RFP-CSP #1006-26 – TOMBALL HS MULTI-PROGRAM ACTIVITY CENTER

Addendum No. 01

Addendum No:	01	**Issue Date:**	11/06/2026
Project:	Tomball HS - MPAC	**To Drawings + Specifications dated**	10/30/
Prepared By:	PBK Architects, Inc. 11 Greenway Plaza, 22nd Floor Houston, Texas 77046		
PBK Project No:	25046901

1 EXTERIOR ELEVATION - PLAN NORTH
1/16" = 1'-0"

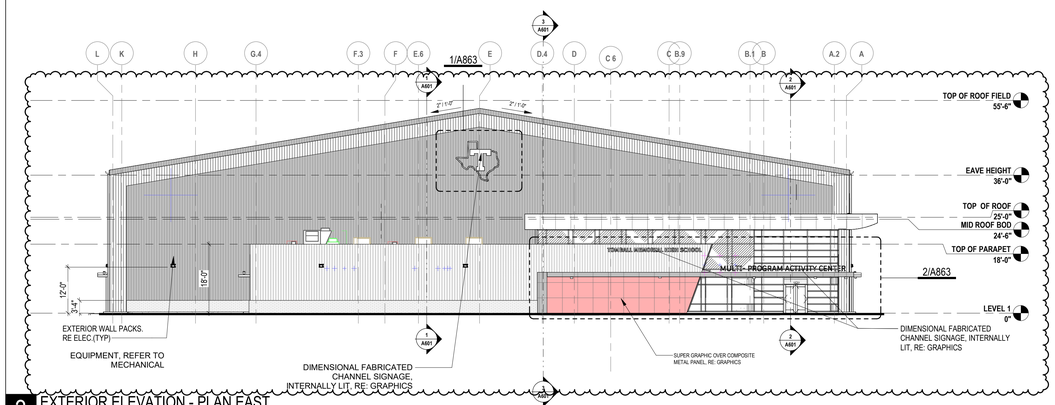
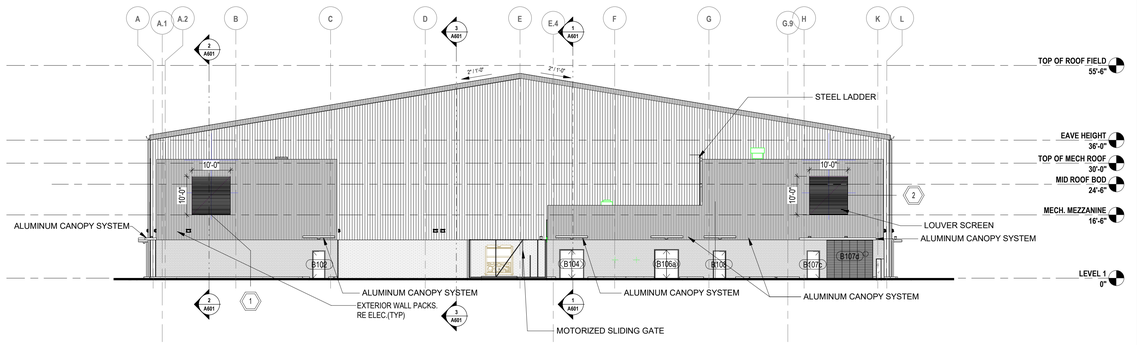
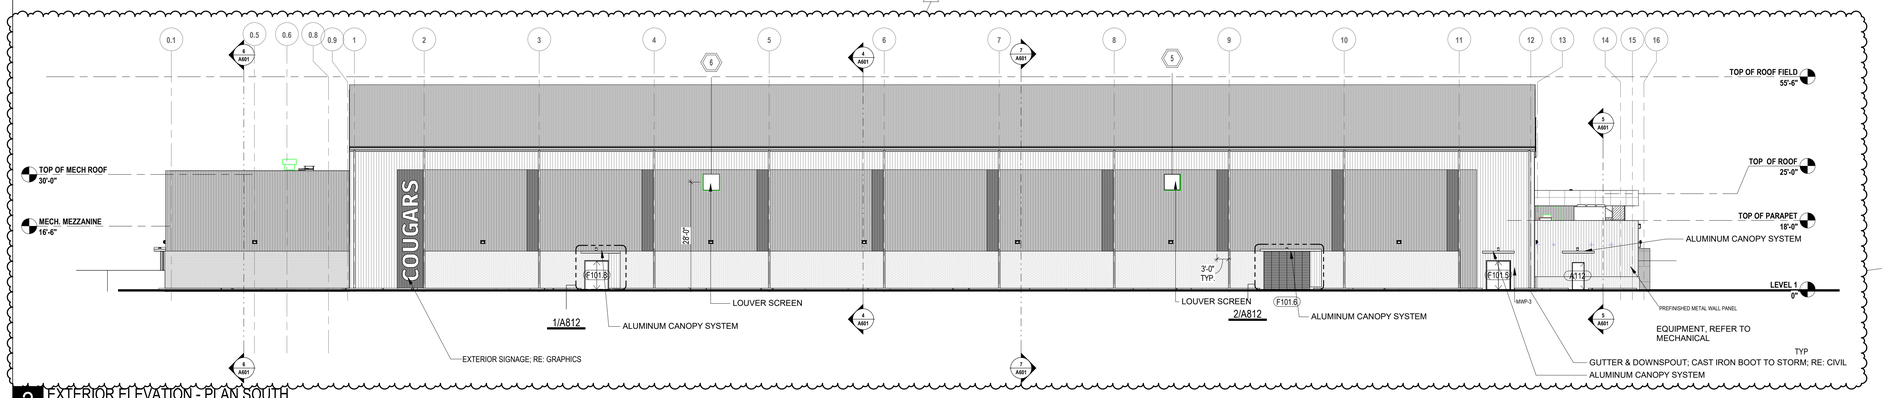
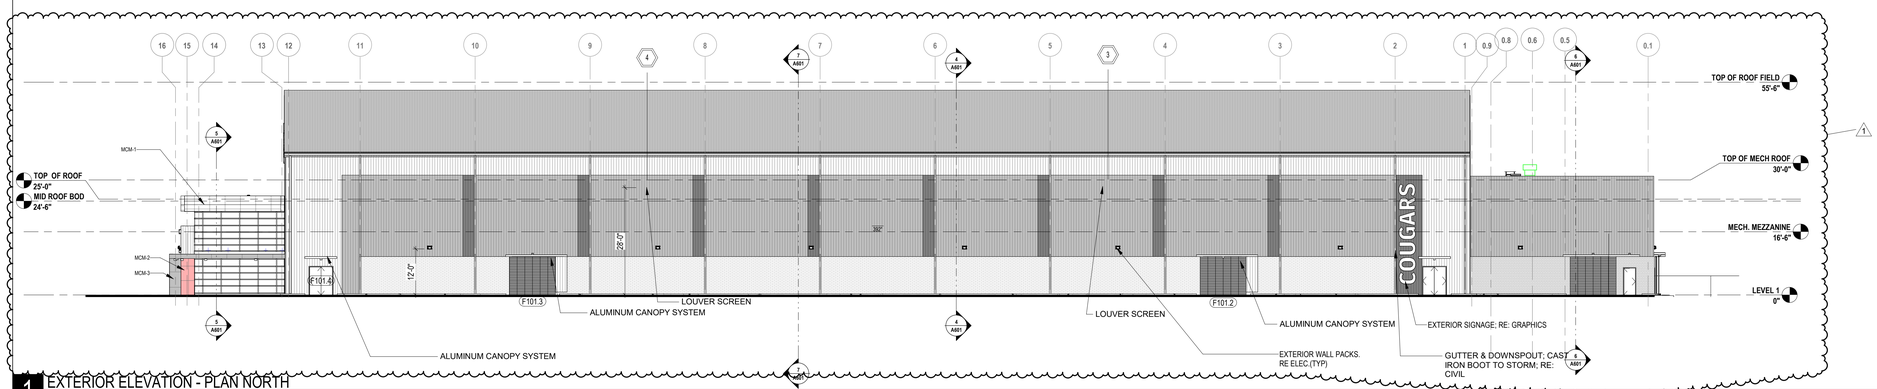
Item No. 11 **Sheet A500 EXTERIOR ELEVATIONS OVERALL :**

l. **Updates** to exterior metal panels to include additional MCM colors and color clarifications for the formed metal wall panels. Detail 5 levels had visibility graphic issues which were cleaned up.

1 LONGITUDINAL BUILDING SECTION
1/16" = 1'-0"

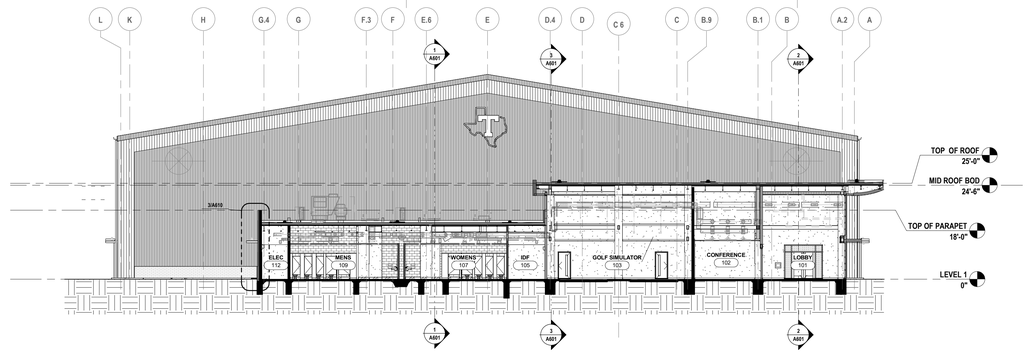
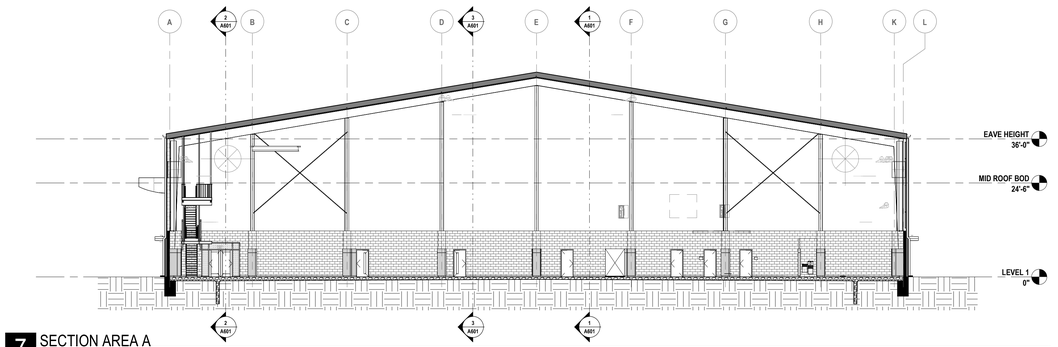
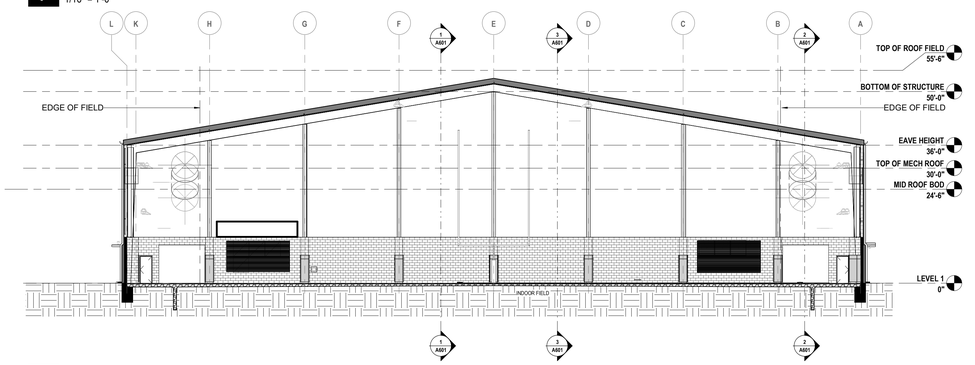
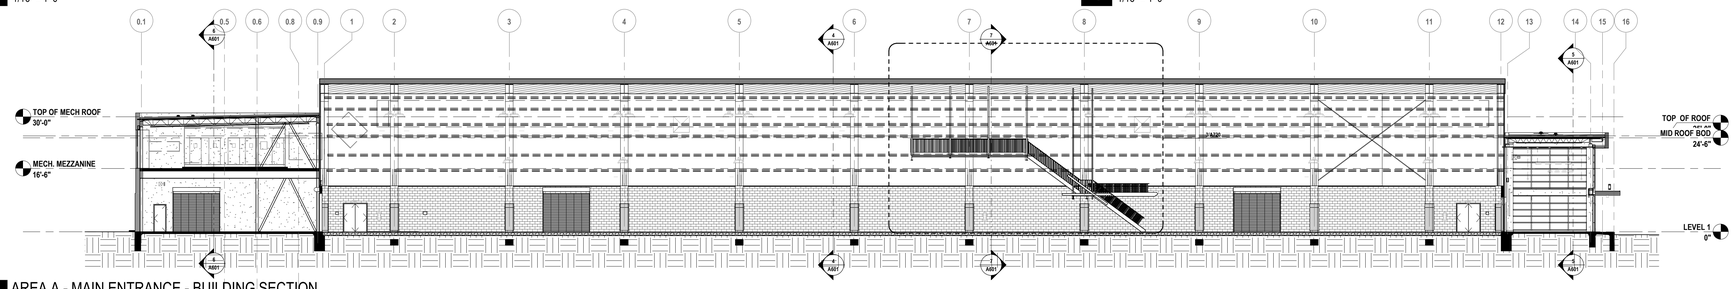
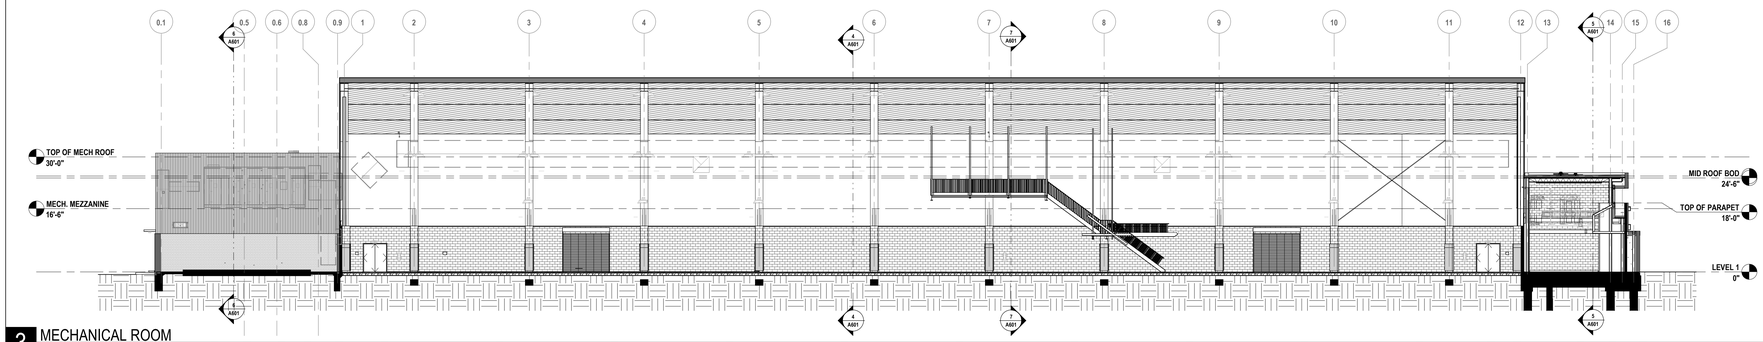
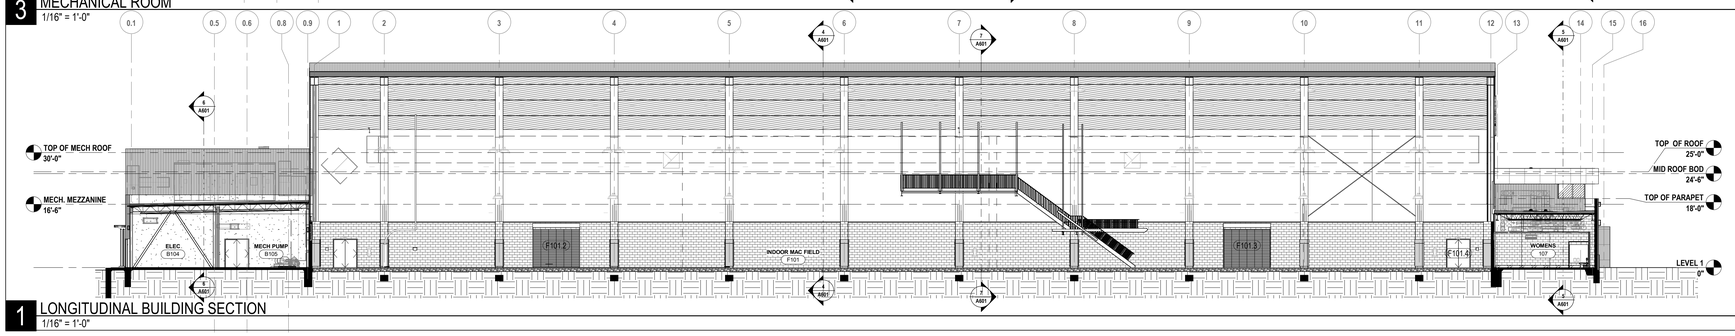
Item No. 16 **Sheet A601 BUILDING SECTIONS :**

q. MEP color turned off for clarity, Foundation system intent representation added to all sections.

A611 - WALL SECTIONS - AREA A

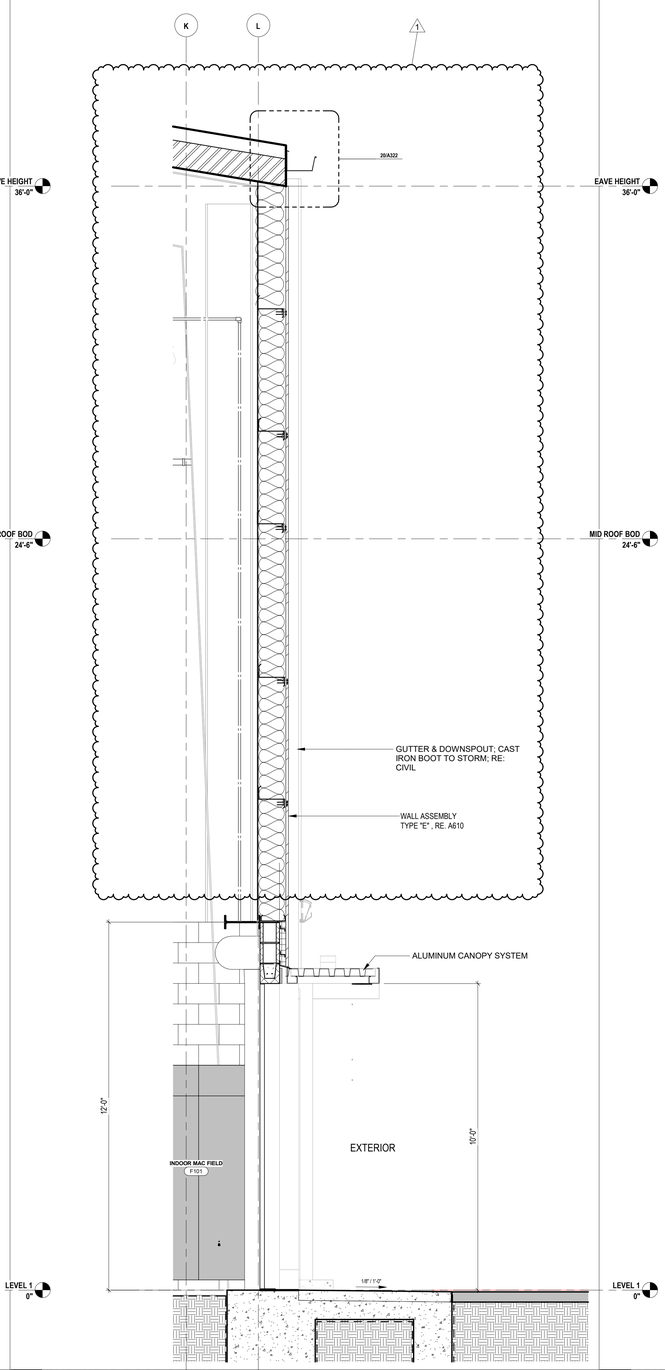
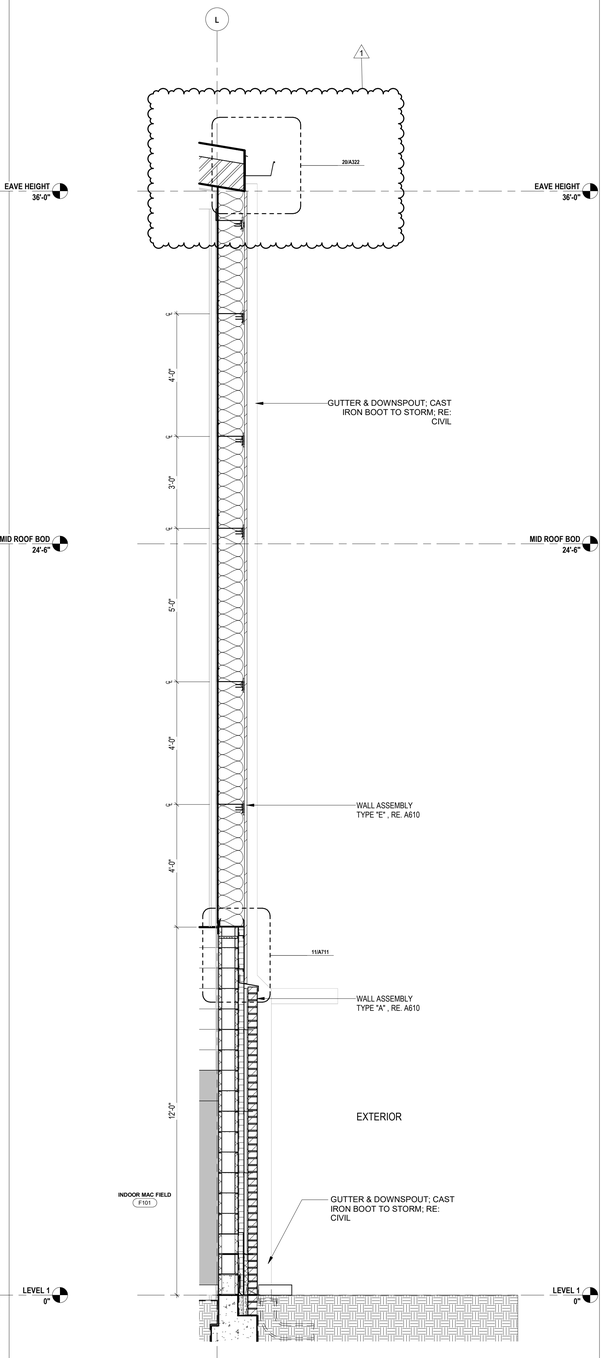
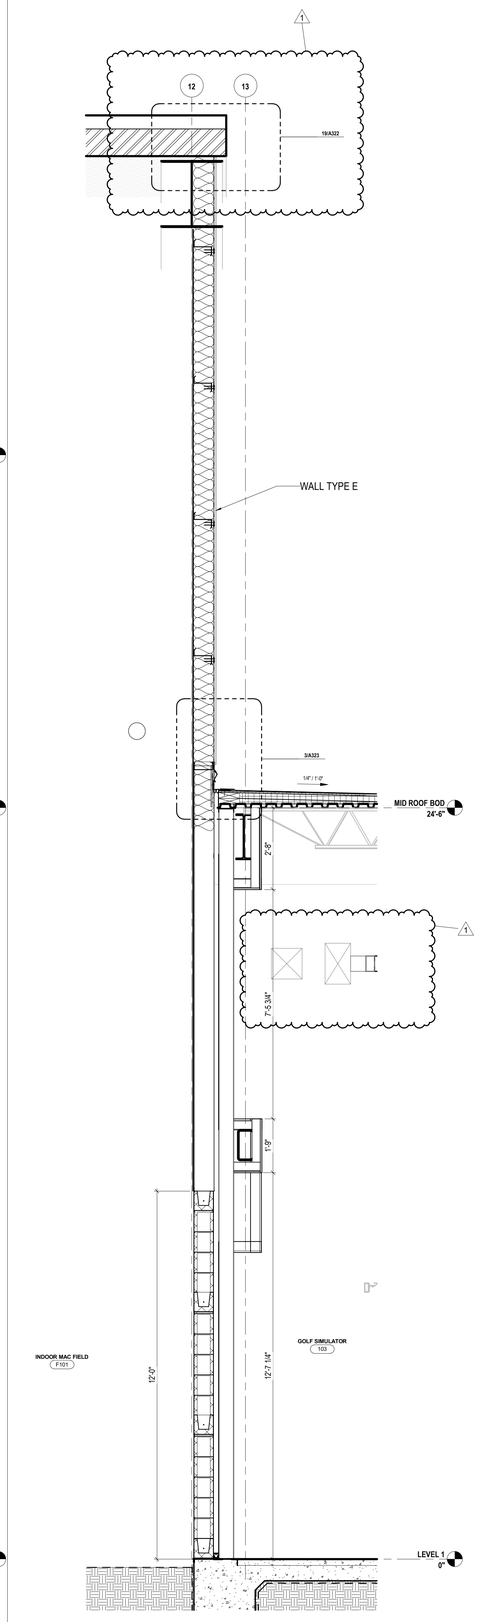
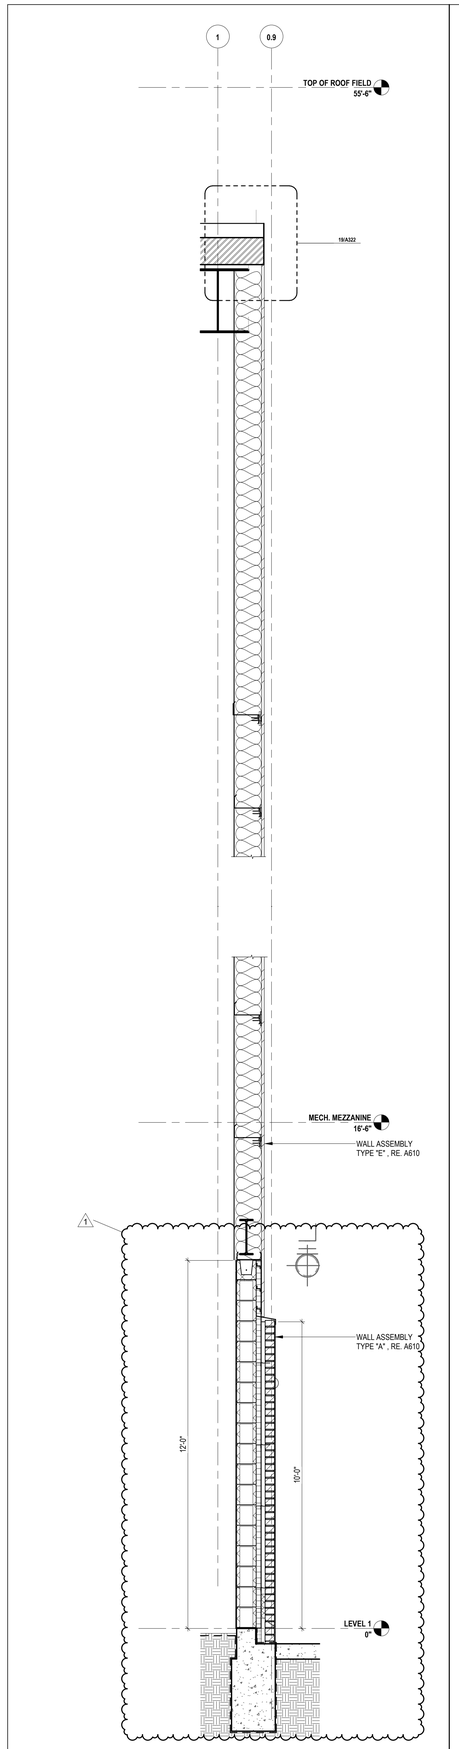
Item No. 18 **Sheet A611 WALL SECTIONS AREA A :**

a. MEP color removed for clarity. Parapet detail callouts added, **.**
